Evaluation of the Sunnyside Cogeneration Associates Draft Groundwater Discharge Permit

Stephen T. Nelson

This report represents my review of available documentation regarding the draft groundwater discharge permit UGW570002 by the Utah Division of Water Quality, and perhaps more importantly, geological considerations regarding this permit. The application deals with the disposal of coal ash generated from the Sunnyside Cogeneration Associates (SCA) power plant in Carbon County, Utah. In compiling this report I have highlighted deficiencies in documentation, as well as unfavorable site conditions.

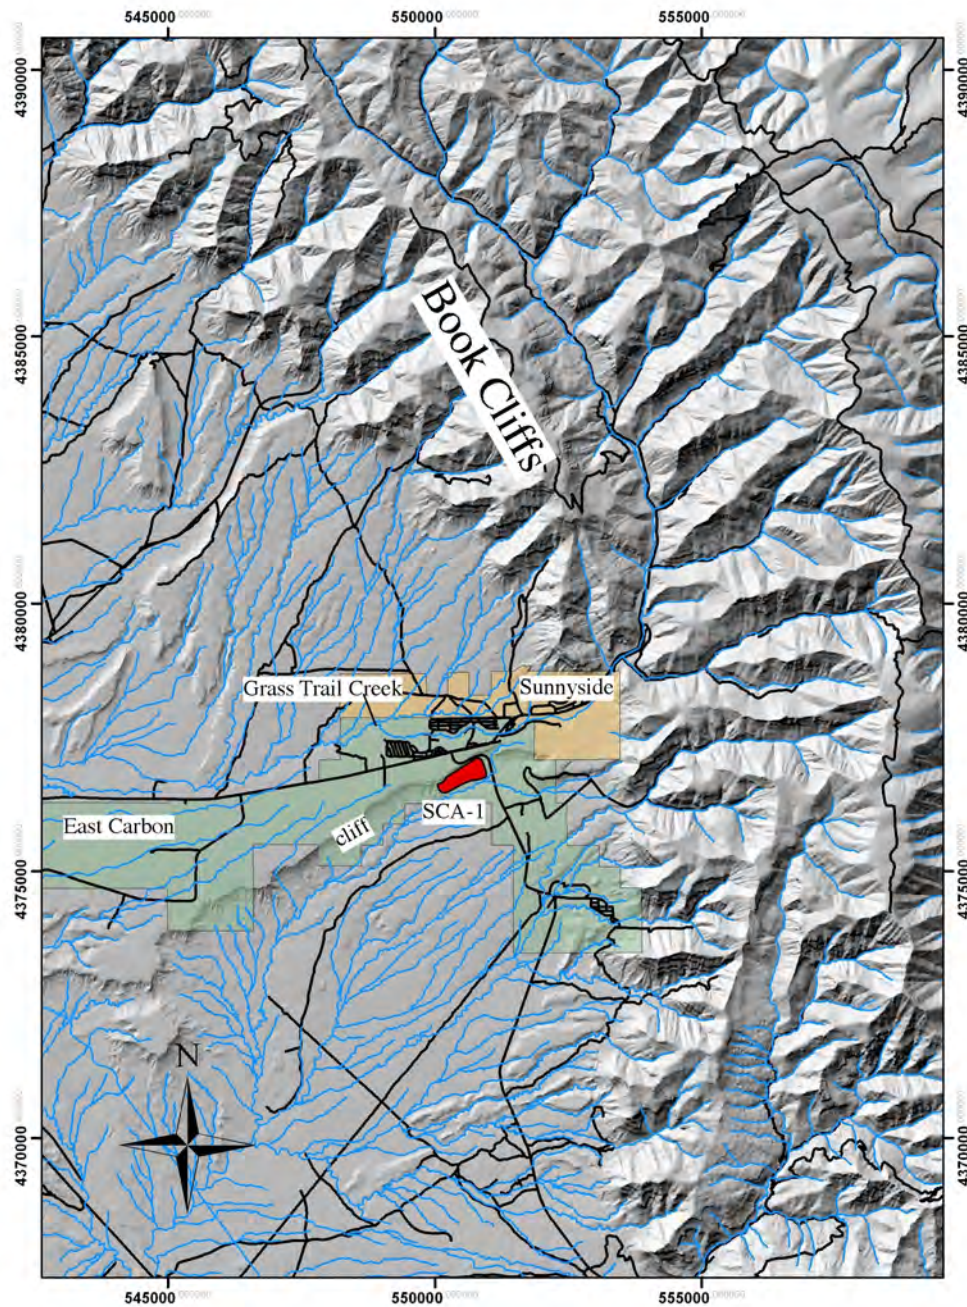
Figure 1 shows the location of coal ash disposal area SCA-1. SCA-2 is not shown because it has not been constructed and its location under the township and range system is too imprecise to evaluate (see below), although it apparently is intended to lie 2 to 3 km east of SCA-1.

A very large drainage basin in the Book Cliffs feeds a stream system known as Grass Trail Creek that flows through the towns of Sunnyside and East Carbon, Utah. It is expected that periodic heavy precipitation events or rapid spring snowmelt could result in large surface water flows or perhaps even debris flows through the area. Note the proximity of Grass Trail Creek to the cliff and SCA-1 in particular (Figs 1 & 2). The implications of this proximity are discussed below.

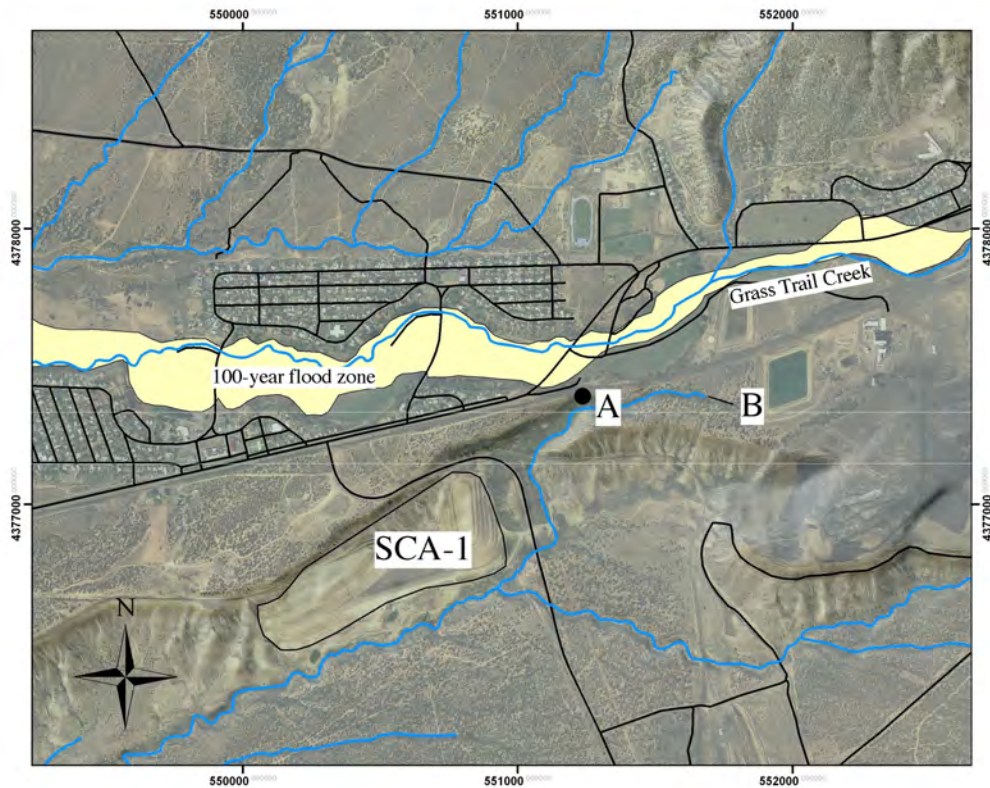
The stream network in the vicinity of SCA-1 causes me considerable concern. Figure 2 illustrates the FEMA 100-year floodplain along Grass Trail Creek just north of the landfill. At point A (Fig. 2) the floodplain is within about 70 meters of Drainage B. Figure 3 further illustrates that, within the resolution of Google Earth data, there is little by way of a topographic barrier to flood waters being diverted into Drainage B in this area (Fig. 3).

Stream capture or stream piracy is a well-known phenomenon by which drainage networks are modified by capturing flows of one system and diverting them into another. A significant stream flow/flood event at or upstream of point A (Fig. 2) could divert flows from Grass Trail Creek, and its entire collection system, into the stream networks south of the cliff, and do so permanently. Were such an event to occur at point A, high stream flows would inevitably, and directly, impact the integrity of the pile. Were Grass Trail Creek captured at or any point up gradient from point A, high flow events might compromise the southern (and down-slope) side of the pile via widening and down cutting of the channel. Given the proximity of Drainage B and Grass Trail Creek, diversion of the latter stream south of the cliff seems likely if not inevitable in the near geologic future². It appears as if a 100-year flood event may approach diversion.

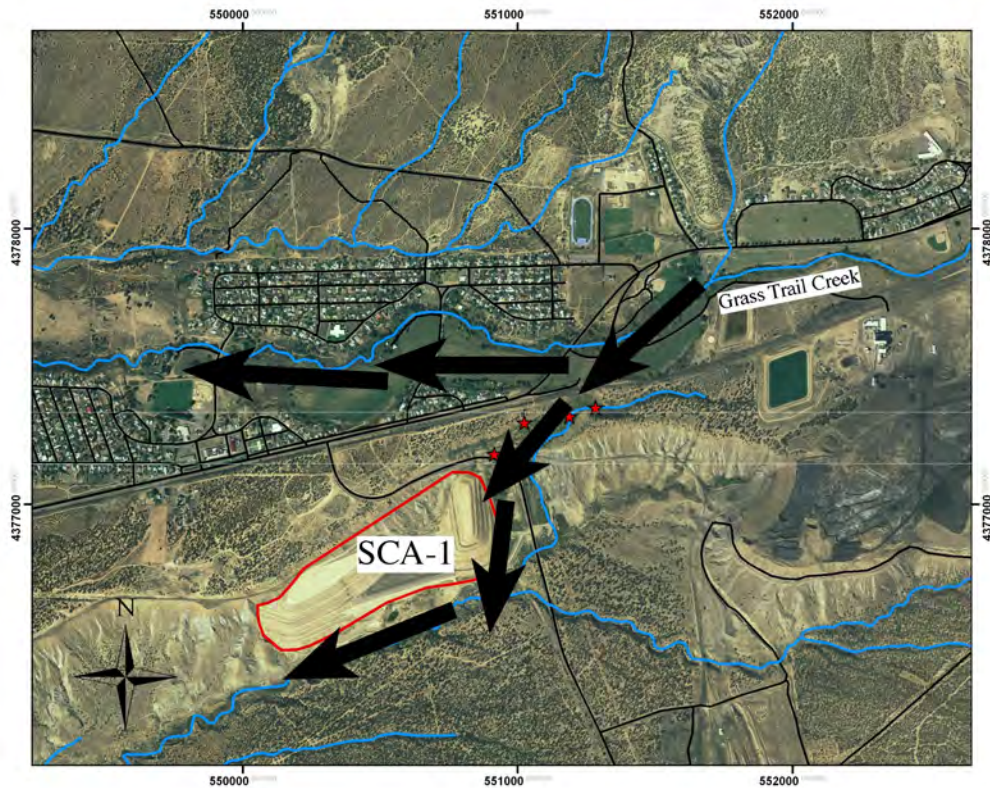
Underflow (i.e., shallow groundwater flow in alluvium parallel to the overlying stream) beneath Grass Trail Creek is clearly being partially diverted at point A down the cliff face and into the drainage south of SCA-1 (Fig. 4). This is evidenced by phreatophytes (e.g., willows, marsh grasses, etc.) growing along in the cliff face, as well as mapped seeps and springs. Furthermore, this flow system is clearly impacting (bringing water into or beneath?) the eastern end of SCA-1. Phreatophytes and seeps mapped by SCA (see map in Sample Analysis Plan) indicate that there is an active flow system to receive seepage from the pile and to transport it further down gradient.

If piracy of Grass Trail Creek were to occur, all of its underflow may be diverted along and beneath the stream network to the east and south of SCA-1. In other words, the broad, verdant riparian zone along Grass Trail Creek in the town of East Carbon north of SCA-1 (Fig. 4) may be abandoned and reestablished south of the SCA-1 piles, yet becoming vulnerable to seepage from the landfill.

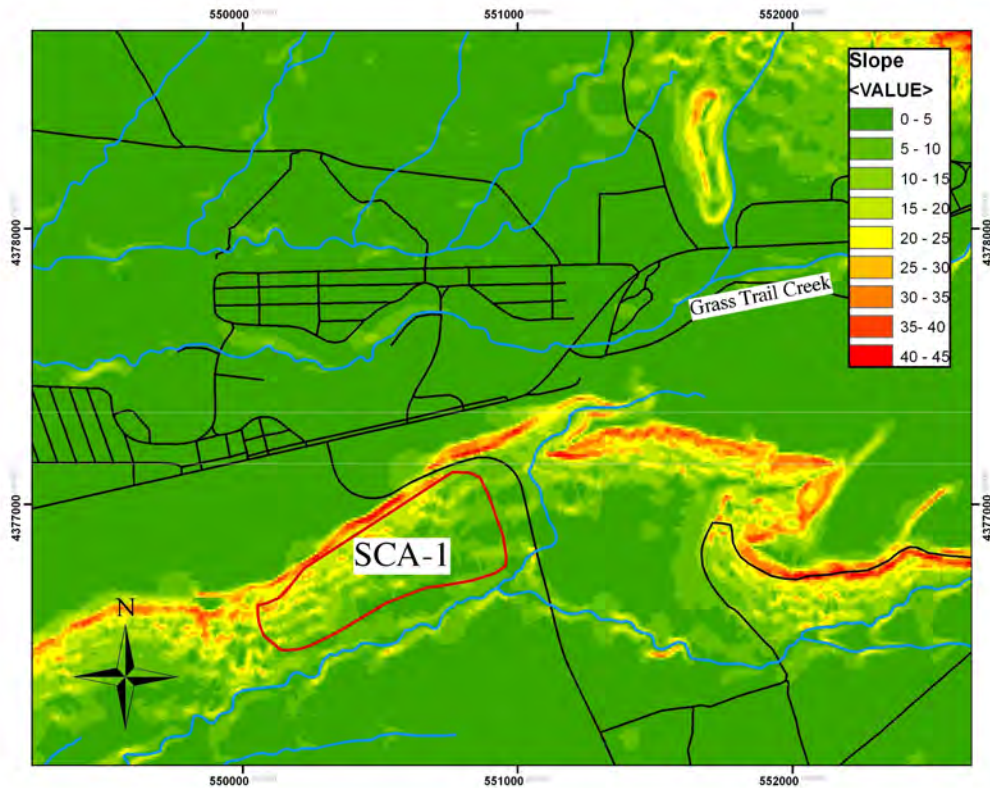
As mentioned above, SCA-1 is largely built into a south-facing cliff, which is in places quite steep (e.g., Fig. 1). Figure 5 indicates that the slopes of the cliff in the vicinity of SCA-1 commonly exceed 20 to 25°. When coupled with surface and groundwater flow discussed above, the wisdom of building this facility into the cliff face comes into question. Loading of groundwater into the east end of SCA-1, erosion of the pile by stream piracy, or undercutting of the pile by present or diverted stream flows to the south of the pile may make this facility vulnerable to slope failure.

Figure A3. Annotated photograph of the east end of the SCA-1 landfill and SCA power plant. View is to the east.

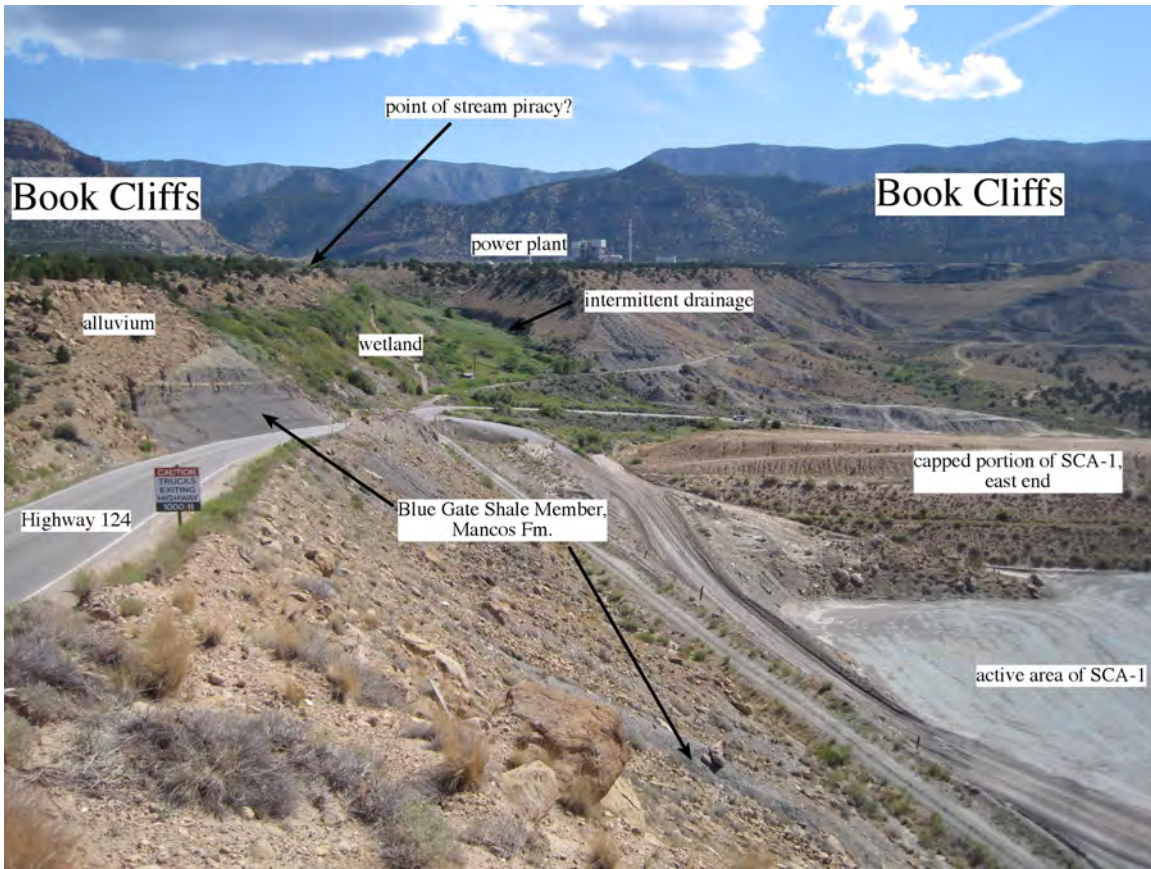
Figure A3 shows a number of important details. The power plant is shown in its relationship to SCA-1 in the foreground (power plant at intermediate distance) and the Book Cliffs in the background. At its east end, the capped portion of SCA-1 is offset somewhat from the natural slope of the cliff. However, toward the west, new areas of excavation are directly on the cliff (Fig. A4). The Blue Gate Shale Member of the Mancos Formation is seen in the slopes, overlain by capping alluvium “holding up” the soft shale. Especially prominent are the diverted underflow and intermittent drainage. Here, the diverted underflow is readily apparent in the vegetation, whereas the path for the potential diversion of Grass Creek Trail is also obvious.

Figure A5. View to the southwest from near Bruin Point on the crest of the Book Cliffs back toward Sunnyside, Utah.

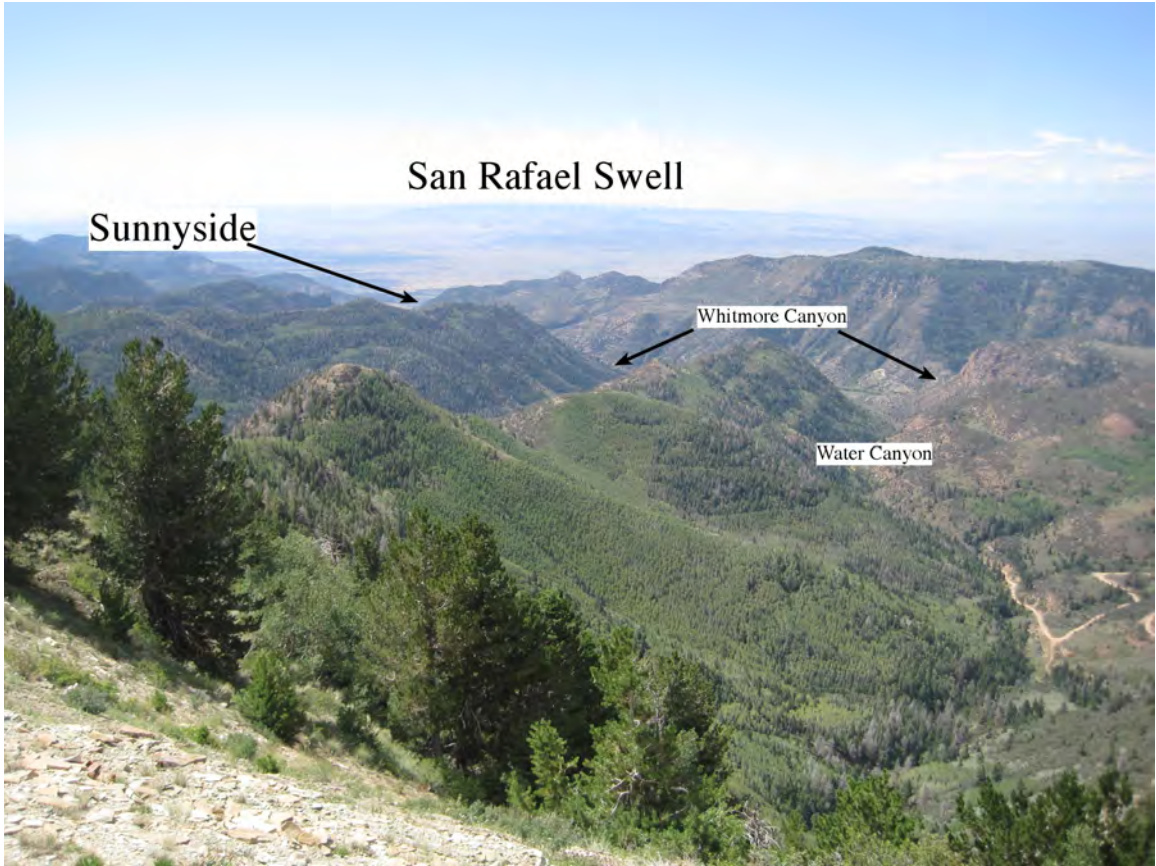
After inspecting the power plant and SCA-1 area, I traveled into the Book Cliffs via Whitmore Canyon, then driving up the Water Canyon Road to Bruin Point. Figure A5 is a view from the crest at an elevation of >10,000' back toward Sunnyside. With the San Rafael Swell and Sunnyside in the distance, the large system of canyons at high elevation is apparent. The high elevations provide an orographic trap for both summer monsoon moisture and winter cyclonic precipitation. Combined with the large drainage system of canyon networks that feed Grass Trail Creek, the potential for episodic flash floods is readily apparent. This provides important perspective to the SCA-1 site given the potential for stream piracy to divert flows beneath and across the landfill. Also worth noting is the potential for debris flows, which could be enhanced if wildfires were to affect this drainage system.
